Water-Suply.- Deferring for the present,,the consideration of the proposals recommended by the Sanitary Board for carrying out the filtering portion of the scheme for which estimates were called for in G.O. No. 1311M. dated 12-8-95, and stating that the Sanitary Board should direct their officers to de~~n~~vote their attention to the drainage of Cuddapah.

CUDDAPPAH WATER SUPPLY SCHE

Cuddapah water supply

Report regarding Cuddapah Filter Beds.

PLAN OF

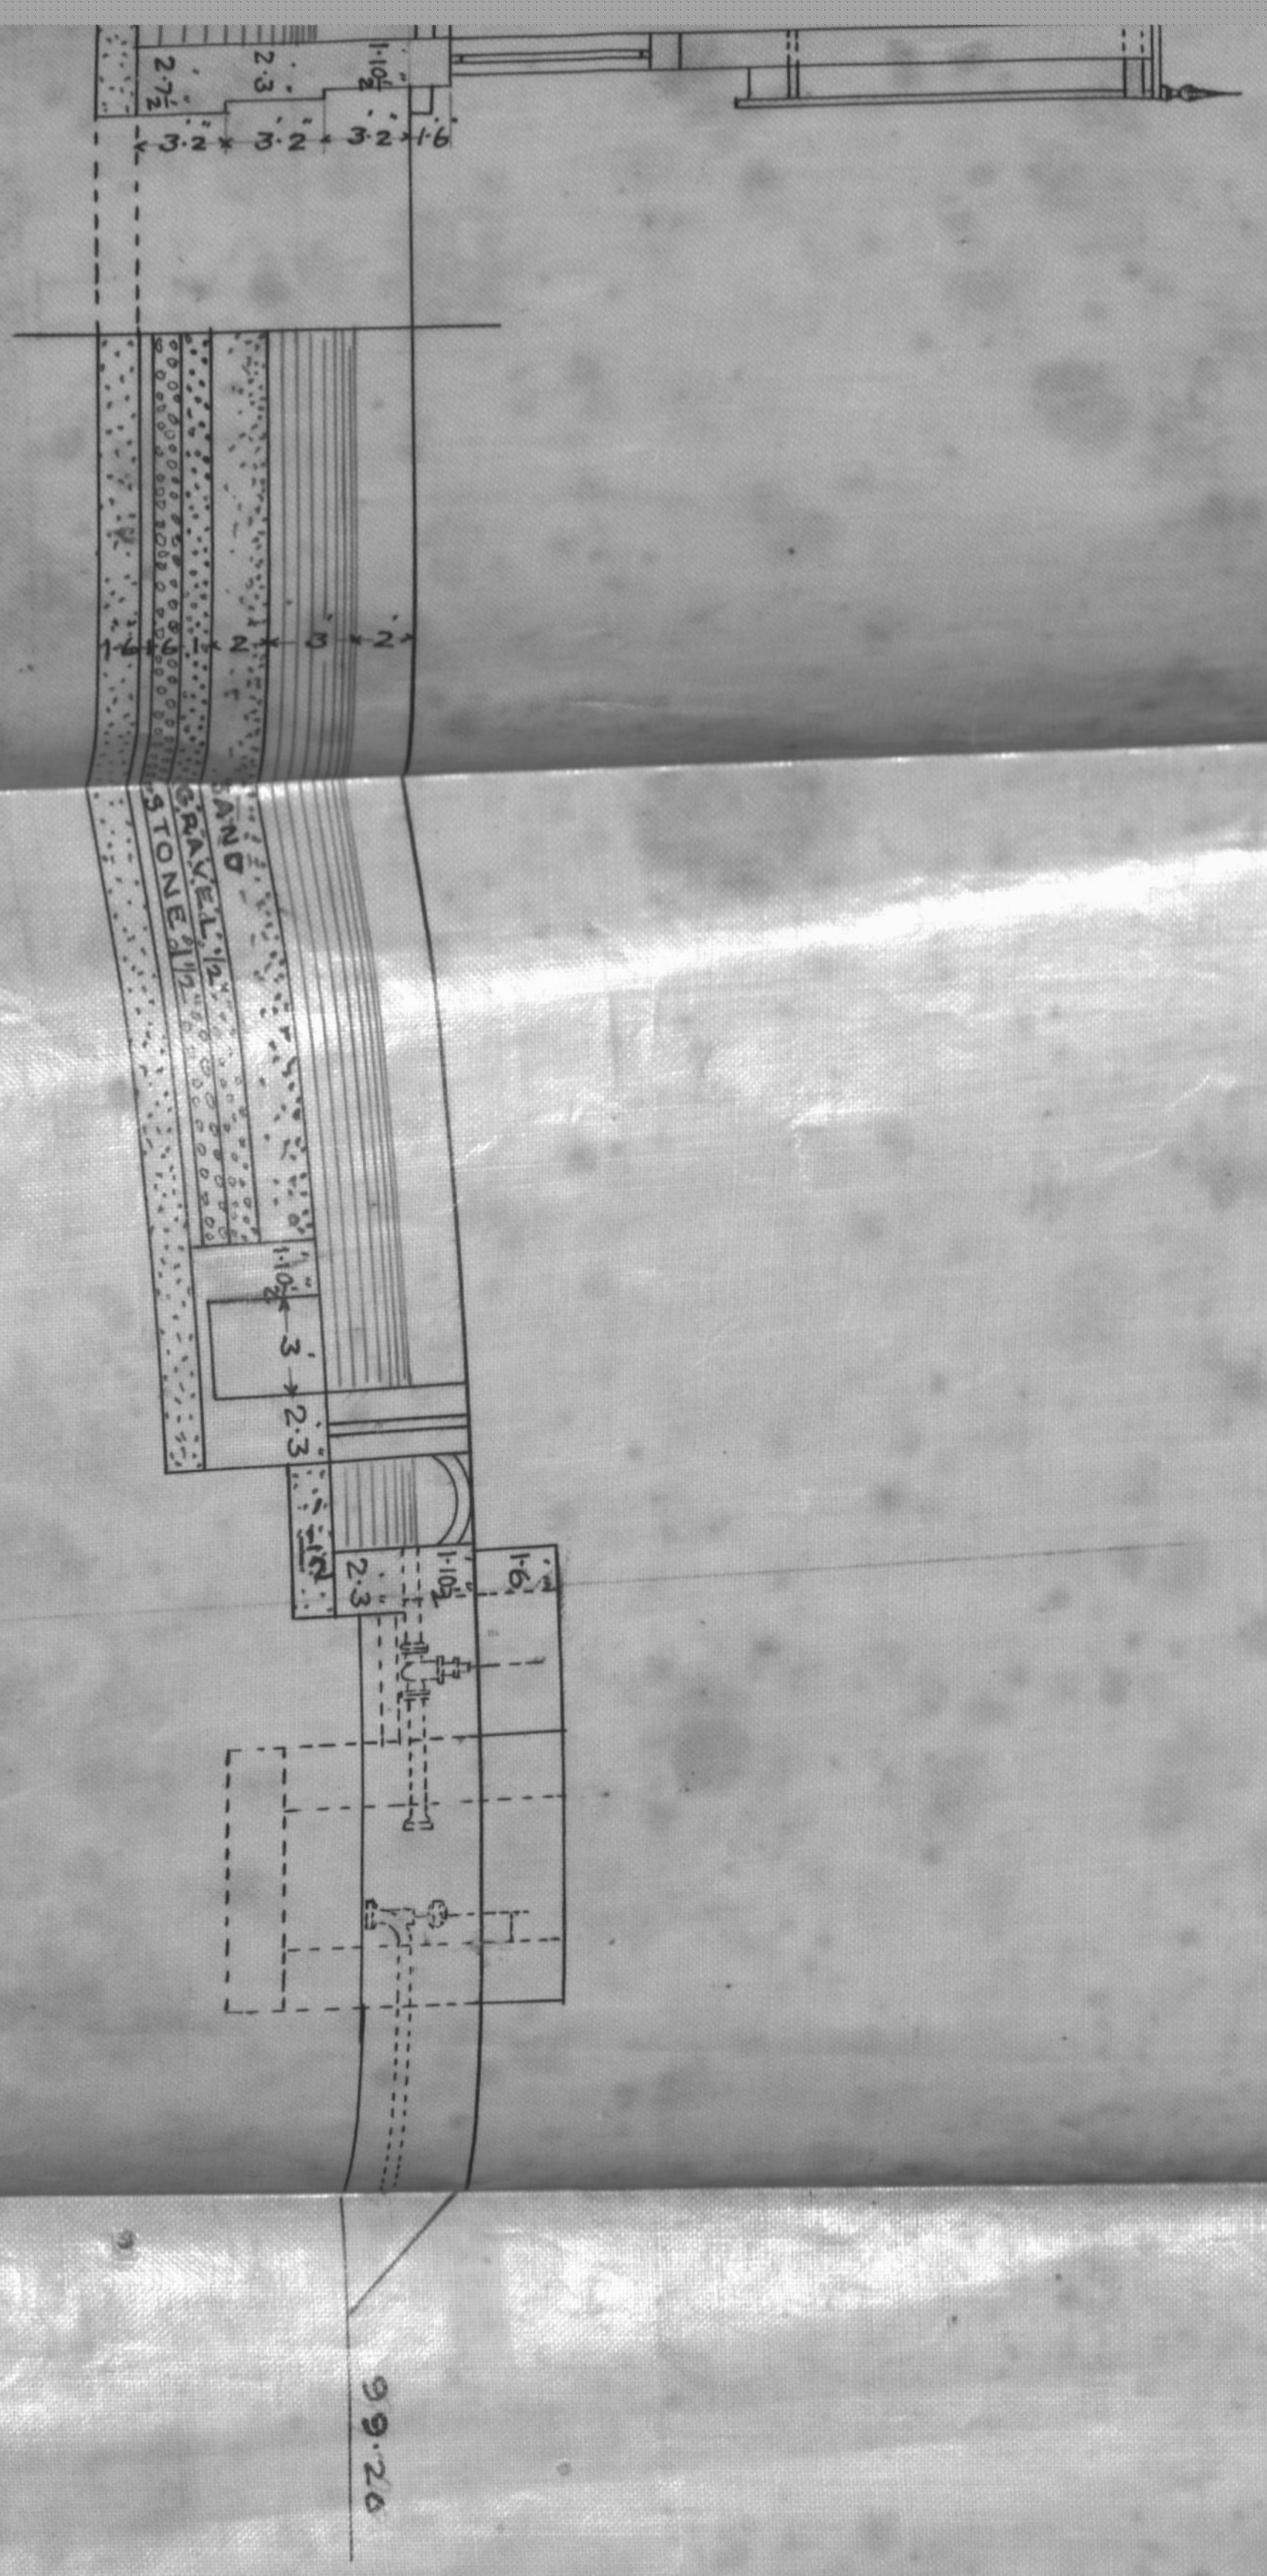
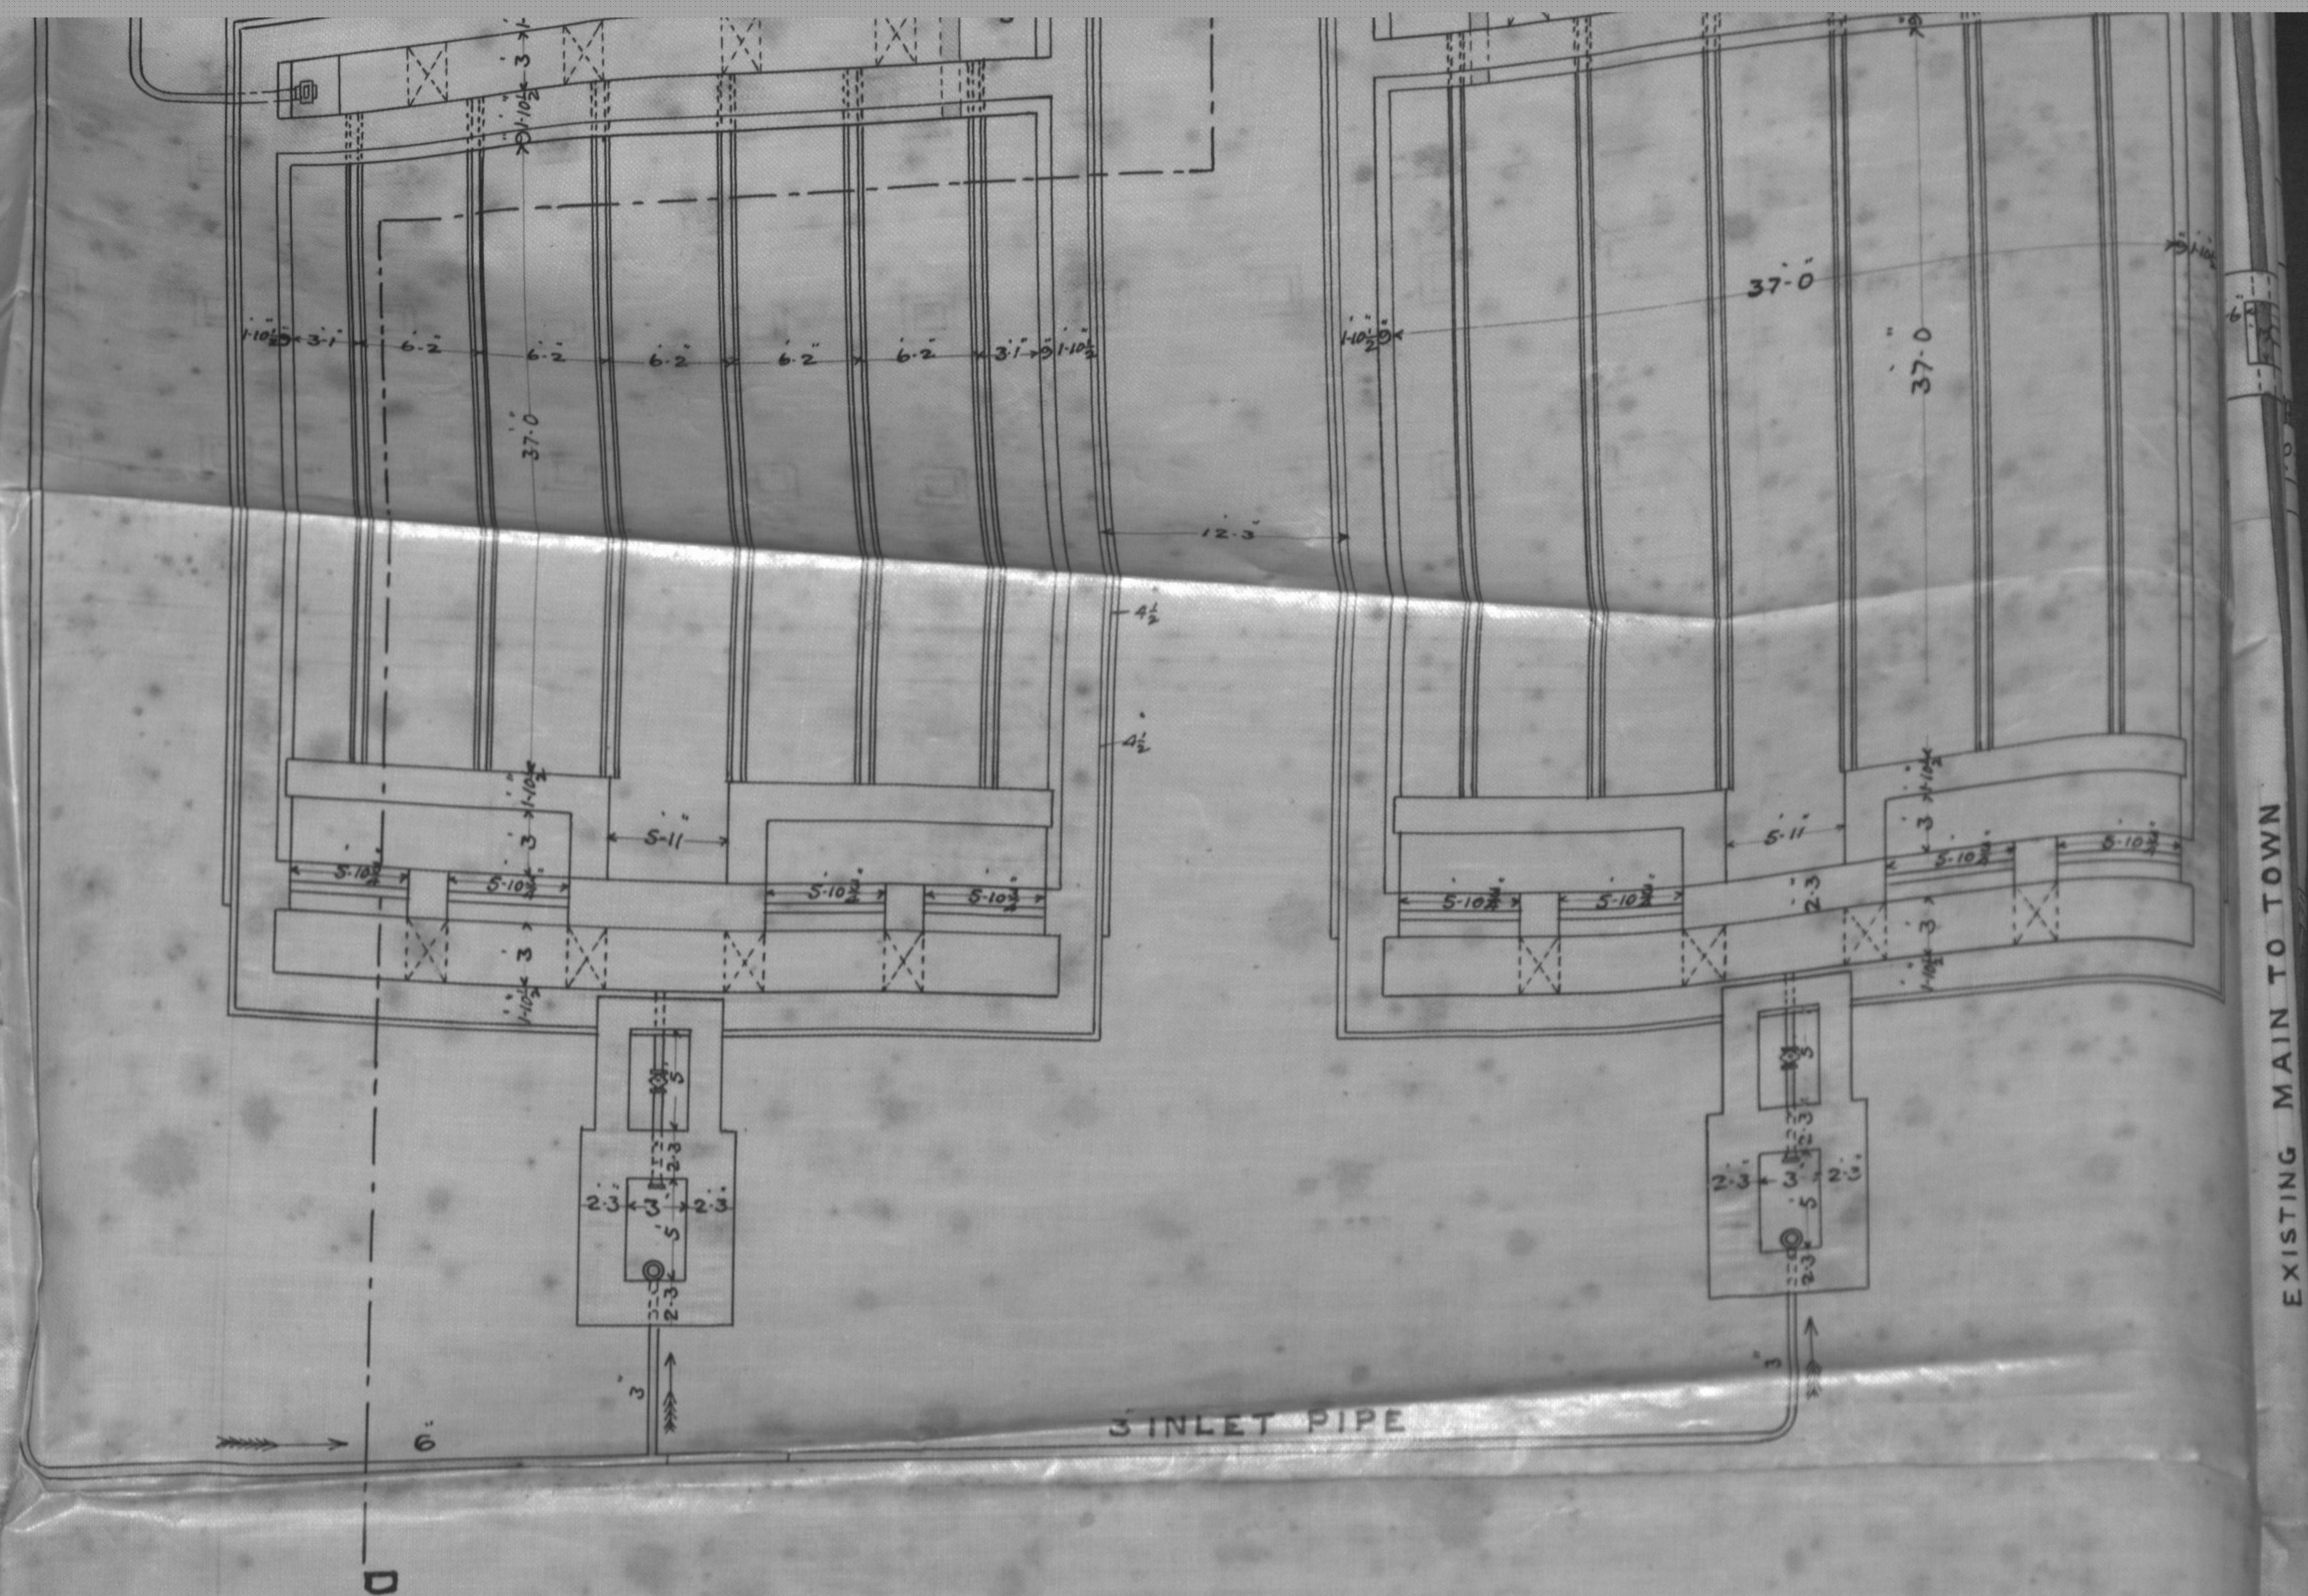
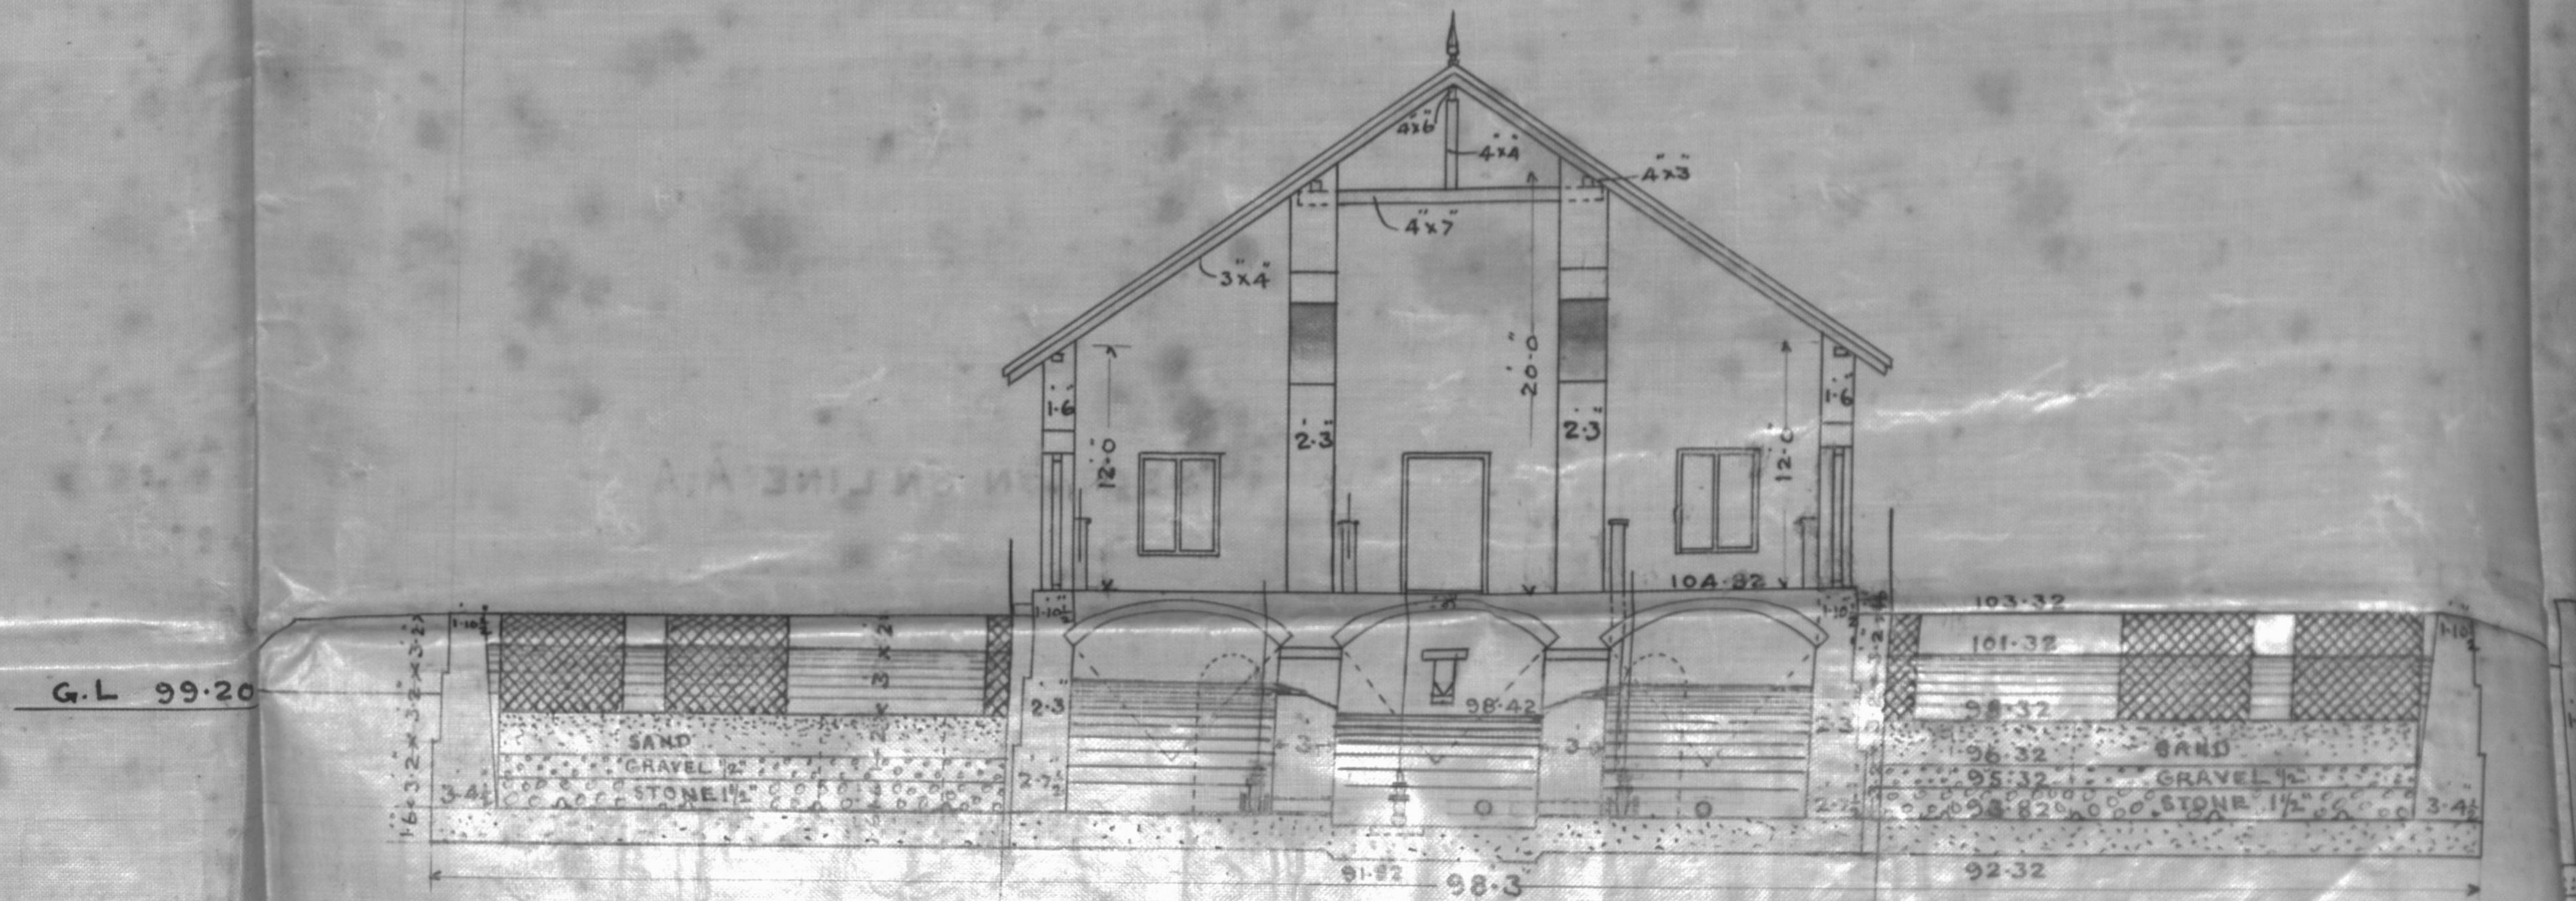
This is an estimate to carry out recommendation (5) of the San. Bd.: page 2 G.O. 12th Augt. 95 no. 1311 L. & M., by ~~supplying~~ ^providing^ filter beds to the existing water supply, & is a measure wh. shd. in any case be carried out for the benefit of the inhabitants. There seems no need to defer it. The estimates may be sanctioned & orders given to commence the work

I wd. not sanction this estt. at present. The water supply comes from a distant point at which, so far as I know, there is no malaria. No doubt filtering is a good thing, but I am of opinion that the urgent matter is the drainage. If that fails we may try filtering. But even then the Sanitarians should demonstrate that the plasmodium malariæ exists in the water. This they have not attempted to do. We cannot afford to spend Rs 33600 on the mere chance that it may so exist. I am surprised that they should have taken up this secondary question now instead of devoting their whole energy to the much more important & primary question of the drainage.

Order. The Govt. will defer for the present the consideration ~~construction~~ of the proposals ~~works~~ recommended by the Sanitary Board ~~can-~~ for carrying out the filtering portion of the ~~not be sanctioned at present as the~~ scheme for which ests. were called for in G.O. 12 Aug. 95 No 1341 ~~Government is not satisfied that malaria~~ It has not been shown that ~~germs are to be found in~~ the water-supply, which comes from a distant point, is infected with malarial germs. Evidence ~~It is to be regretted that the~~ on this point shd. be procured & laid before Govt. H.E. the Govr. moreover considers that the primary & more urgent portion of the scheme is that relating to the drainage, to which the Sanitary Board shd. direct their officers to devote their earliest & most earnest attention.
